## SMYRNA MUNICIPAL PLANNING COMMISSION

### MEETING MINUTES DECEMBER 7, 2023

1. Addition to Villages of Valley Green, Section IV - **Request to be deferred**  
 Enon Springs Road W & Wildwood Drive  
 Owner / Developer: JSD Holdings

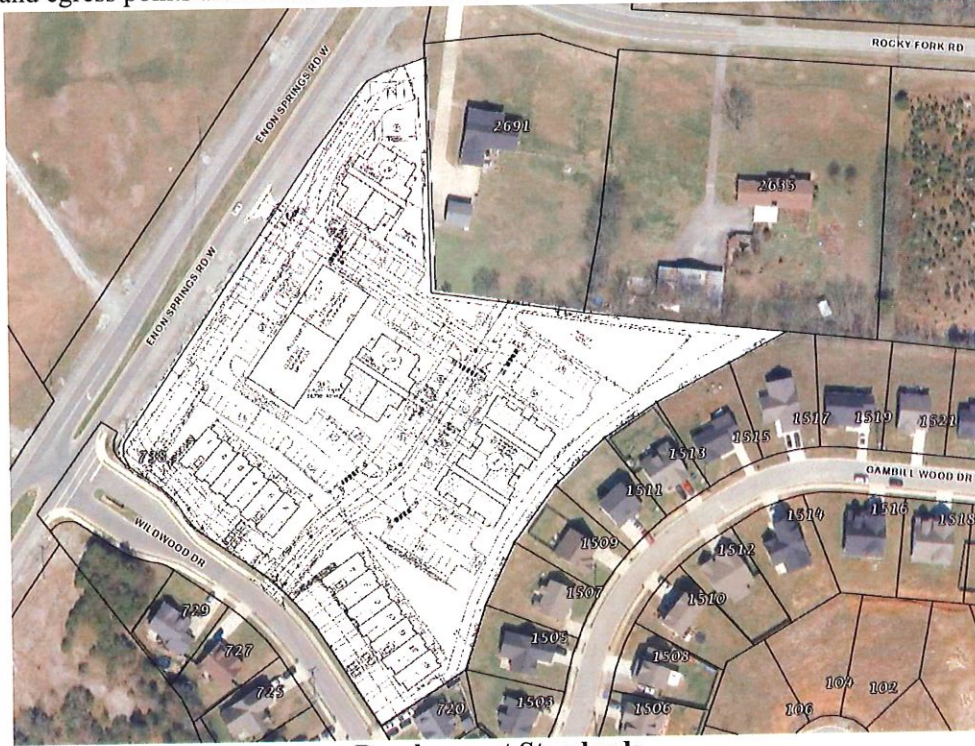
1. Provide architectural elevations for the commercial building showing all four sides, the height of the building, the material percentages per wall face, and the material percentages for the overall building.

2. Provide architectural elevations for the three proposed apartment buildings and the proposed townhomes showing the heights of the buildings and proposed materials. Depending on the height of the building, a wider drive aisle may be required.

3. Please show additional dumpsters for the development. Provide dedicated trash receptacles for the commercial building.
4. Please show on the plans whether the townhomes will be a for sale product or rental. This affects how the units are provided sewer.

5. Extend sewer to the property to the north east (Gambill).
6. Provide an auto-turn using the Town of Smyrna ladder fire truck. Auto-turn cannot enter parking spaces when turning.

7. 5,250 SF of commercial is allowed by the approved PUD. The proposed building on the plans show 9,000 SF. Either reduce the size of the building or request a PUD amendment to allow a larger commercial building.

13. Please show a loading/unloading zone for the commercial building which does not interfere with the auto-turn.
14. Add curbing to the cross-section of the proposed paving.

15. Provide a Type C landscape buffer between the multifamily uses and all of the surrounding single family uses.
16. Show landscaping/streetscaping between Building 2 and the commercial building.

- 17. Utility plans are under review.
- 18. Please show handicapped parking spaces spread throughout the development to serve all the apartment buildings as well as the commercial building. Handicapped people should not be crossing drive aisles to reach their destination building.

1. Almadillo Retail Center

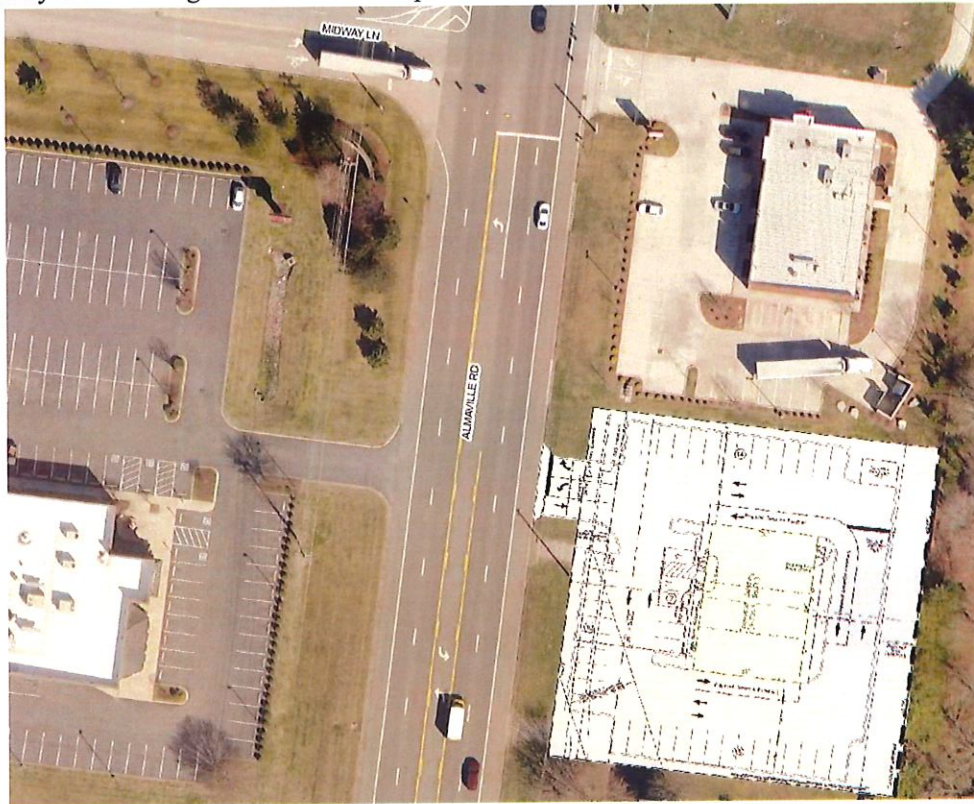
1. A combination plat must be recorded prior to issuance of a building permit.
2. Any work within TDOT right-of-way including construction of the new access requires a permit from TDOT. Please provide prior to issuance of any permits.

3. Submit construction plans for the proposed sewer main.
4. It appears that the dumpster enclosure is set up for two dumpsters for three businesses. If this proves to be inadequate and a third dumpster is needed in the future, the enclosure will have to be rebuilt to enclose all needed dumpsters.

5. There is a possibility that in the future the center turn lane of Almaville Road may be removed. At that time, the access to this site would become a right in/out only.

6. Adequate parking is shown to meet the Zoning Ordinance. The third space within this building cannot be used as a restaurant in order to maintain adequate parking for the site.

7. Provide details on the proposed retaining wall.
8. If the building is sprinkled, the FDC will be required to be no less than 30' off the building and within 100' of the fire hydrant.

9. The outfall from the underground detention is shown extending into the public sewer easement. Please provide construction plans showing no conflicts with the sewer line.

10. CUD's existing infrastructure is not adequate to meet the fire flow requirement of 1,500 GPM for this development on the eastern side of Almaville Road. Currently, CUD can only meet approximately 250 GPM on the eastern side of Almaville road at this location due to the limited flow of the existing two (2) inch water main. CUD can meet the 1,500 GPM fire flow requirement only on the west side of Almaville Road via the twelve (12) inch main.

- 2. Davis Park Commercial, Lot 4  
Corner of Old Nashville Hwy. & Davis Park Dr.  
Owner/Developer: Richland South LLC/Beltway LLC

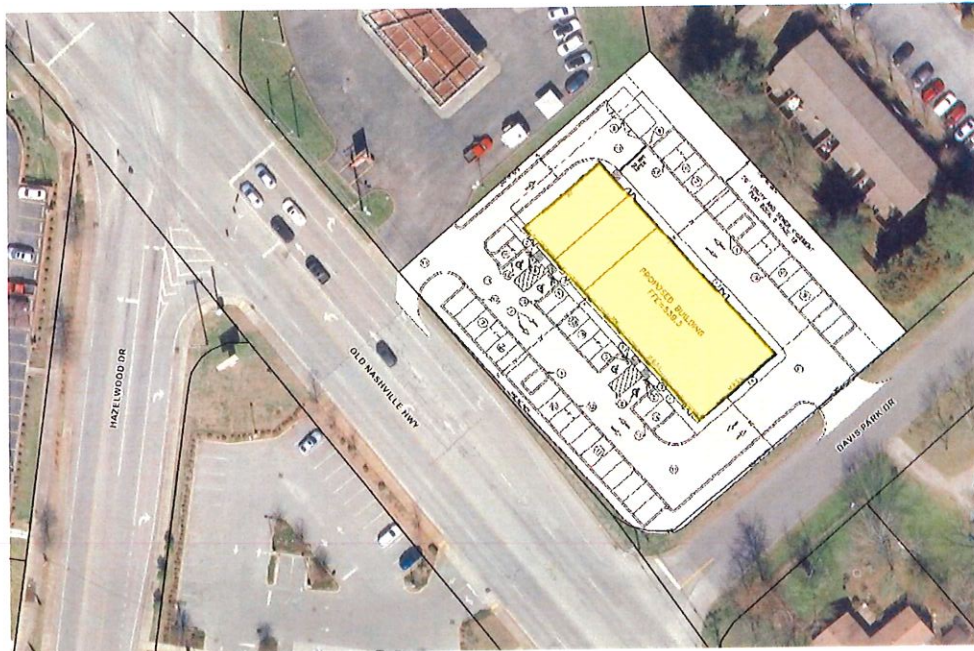
1. A shared access easement will be required for the adjacent tract to the northwest. If one already exists, please provide documentation.
2. Based on the construction type, the building will be required to be sprinkled.
3. Adequate parking is shown to meet the Zoning Ordinance. However, the third space within this building cannot be used as a restaurant in order to maintain adequate parking for the site.
4. It appears that the dumpster enclosure is set up for two dumpsters for three businesses. If this proves to be inadequate and a third dumpster is needed in the future, the enclosure will have to be rebuilt to enclose all needed dumpsters.
5. Submit utility construction plans.

3. Redstone Federal Credit Union  
 Corner of Sam Ridley Pkwy. W. & Huginn Ln.  
 Owner/Developer: Redstone Federal Credit Union

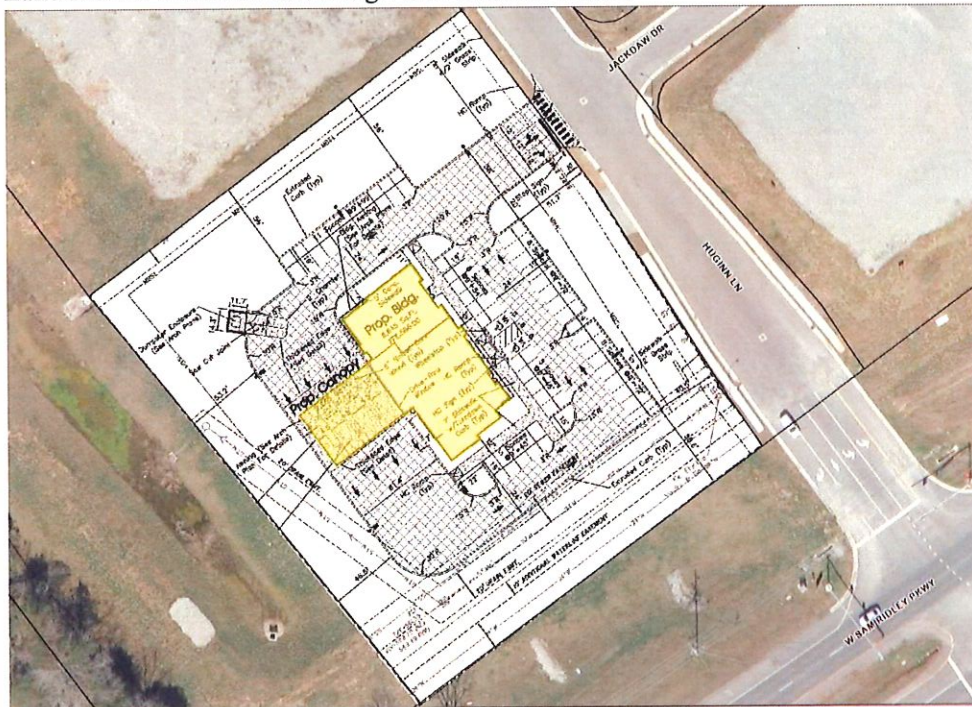
1. Please show adequate streetscaping along Huginn Lane meeting MTEMC requirements for landscaping in an easement as well as streetscaping requirements.
2. Due to the number of parking spaces provided, the second tenant cannot be used as a restaurant.

4. Stewart Creek Station  
NE Corner of Poplarwood Drive & Almaville Road  
Owner/Developer: Mayan 2022 Inc/Hardik Patel

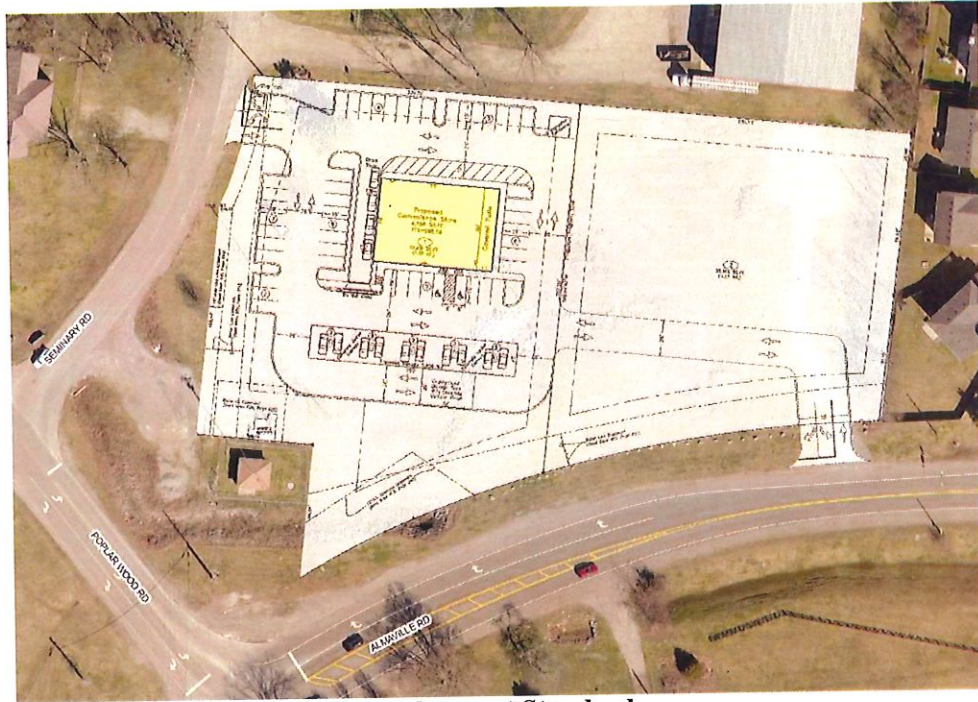
1. The subdivision plat creating the two lots is required to be recorded prior to issuance of a building permit. This would need to include the ingress/egress easement across Lot 2 benefiting Lot 1.
2. An entrance is shown on Almaville Road (SR-102). The current gravel drive at this location has not been permitted by TDOT. TDOT approval will be required for the entrance and it must meet all TDOT design standards.
3. Any improvements recommended by the traffic study must be completed by the developer.

1. A left turn lane is shown on Almaville Road into the Project Site.
  2. Begin the RIGHT TURN LANE from Almaville Road onto Poplar Wood Road after the Project Site entrance in order not to confuse drivers with the Project Site entrance.

3. The site distance has been checked for the Project Site exit onto Almaville Road.
  4. Bring signal equipment up to current Town of Smyrna standards.

5. Install connection to Smyrna Traffic Operations Center for remote phasing.
  6. Replace signal heads as needed for new turning movements.
  7. Conduct Timing Study to input different timing plans for peak hour traffic. This signal will be a part of the overall ITS project Phases 3, 4, and 5.

8. Make the Poplar Wood Road at Foxland Drive intersection an all way stop.
4. What is the fireflow? This site needs a minimum of 1500 GPM at 20 PSI
  5. Provide the construction type as this may affect the required minimum fire flow.
